Certificate of Appropriateness

210 E. Michigan Street, East Side Commercial Historic District

Replace paired south entry doors with a full-height single wood sash window with wood framed sidelights.

Date issued 7/9/2024

Existing and proposed entry doors

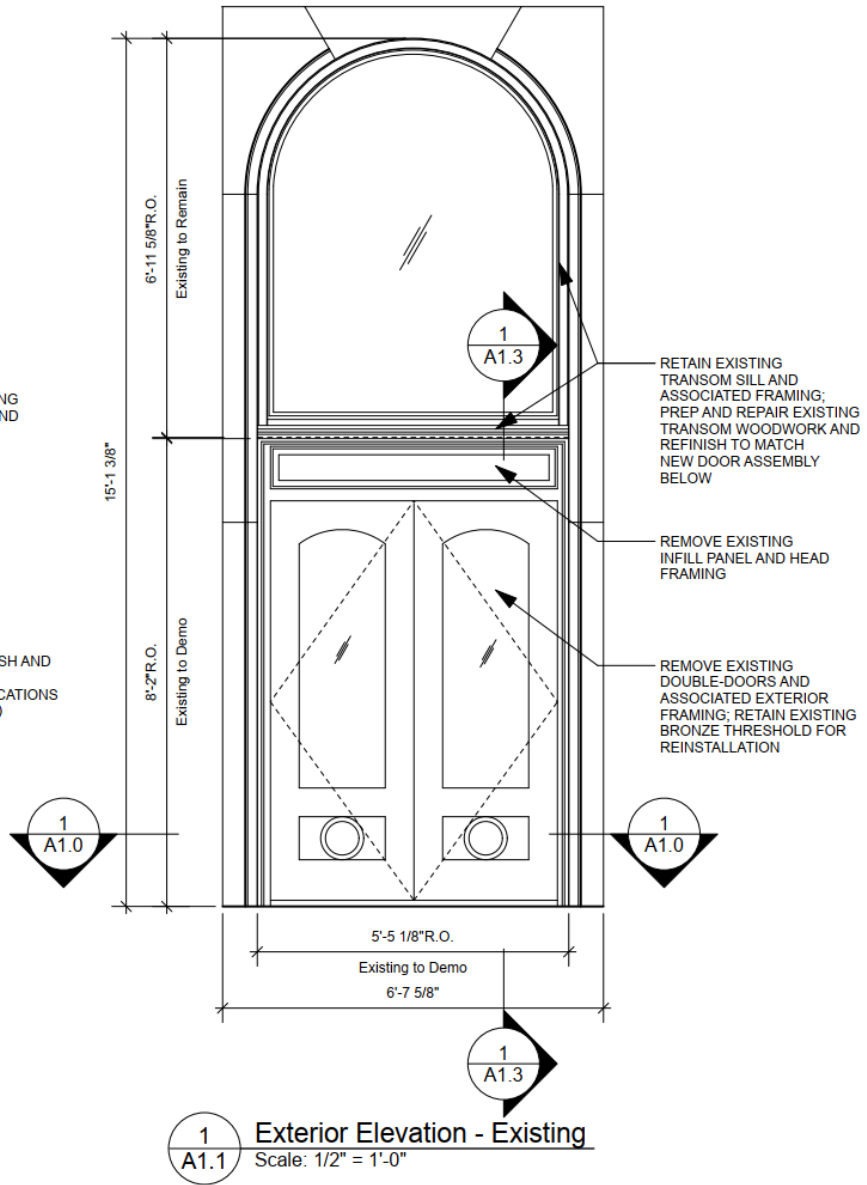
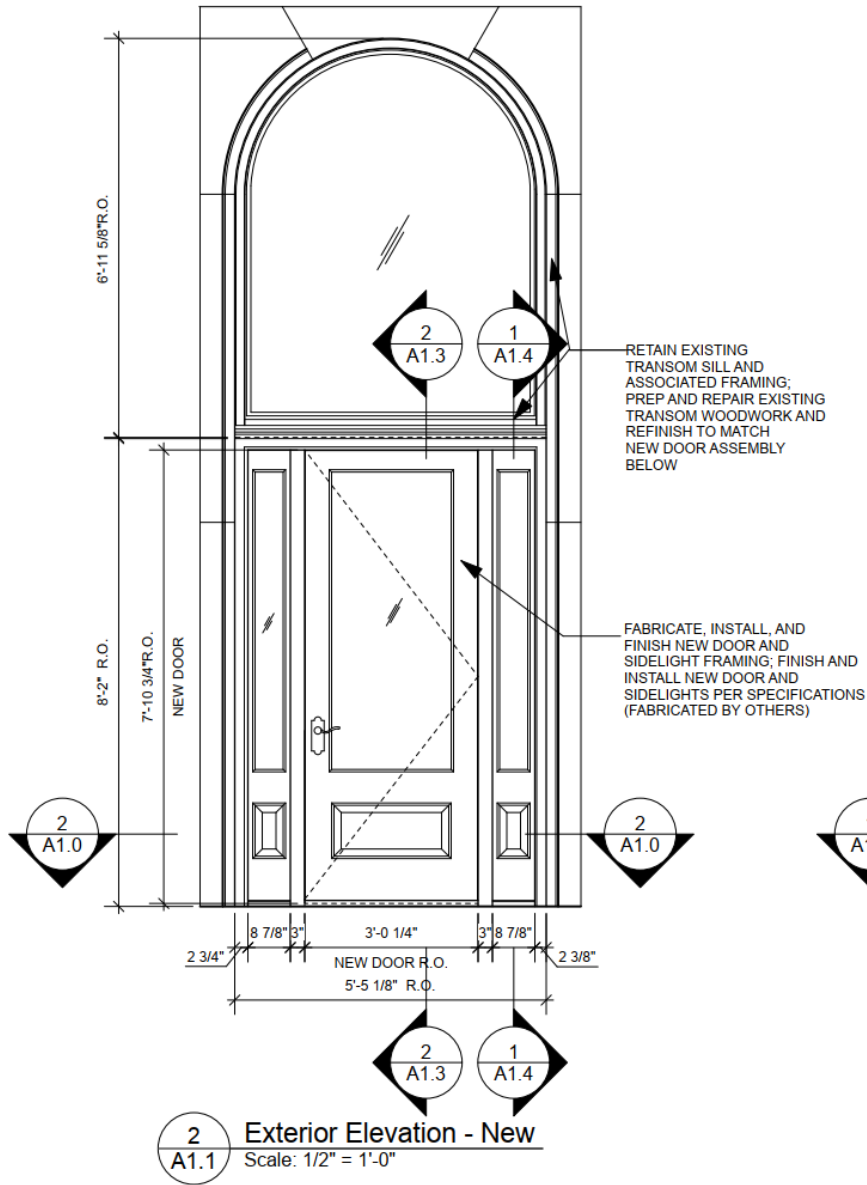
All finish wood must be smooth and free of knots and must be painted or treated with an opaque stain upon completion. Note: when new, bare wood is left exposed to the exterior elements for a period of only a week or two, the life the of the paint job subsequently applied to it will be decreased. The use of a decay-resistant wood for is required for porch areas. Using western white pine or Ponderosa pine is "at your own risk" because this wood has no natural decay resistance and can deteriorate in some exterior settings in just a few years.
